Network Camera Firmware

Version: V5.5.85

Release Note (**External**)

**for DS-2CD3X41G0 Cameras*

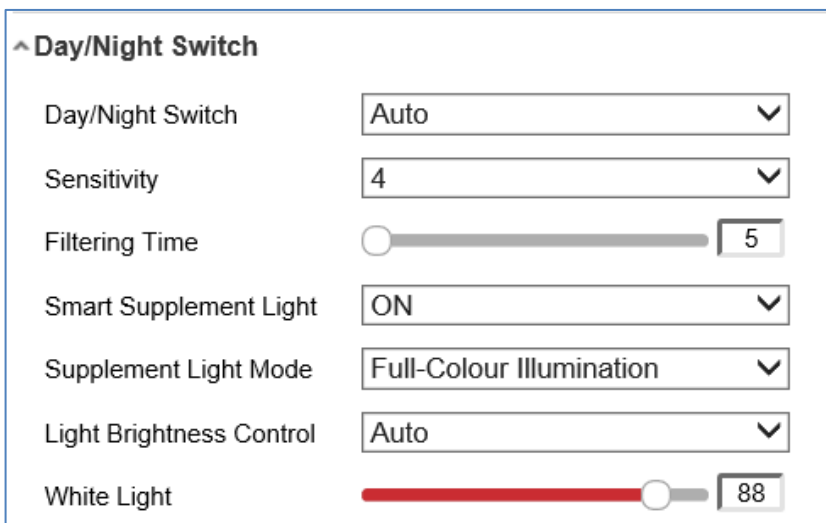
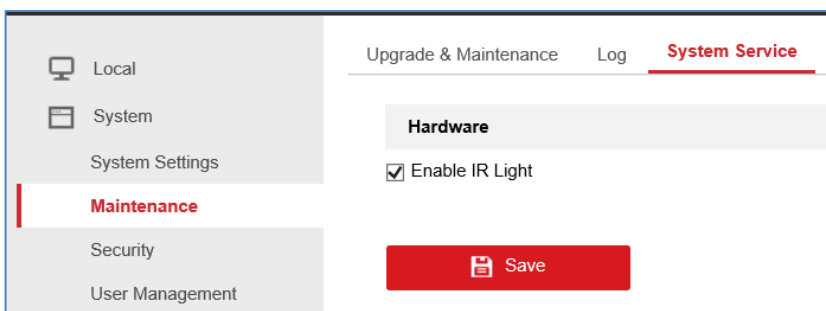
- Change the supplement light setting on webpage of ColorVu camera, delete the 'System'- 'System Settings'- 'External Device' interface and add 'Supplement Light Mode' option on 'Image'- 'Day&Night Switch' interface, the 'Supplement Light Mode' can be set to 'ColorVu Mode' or 'OFF';
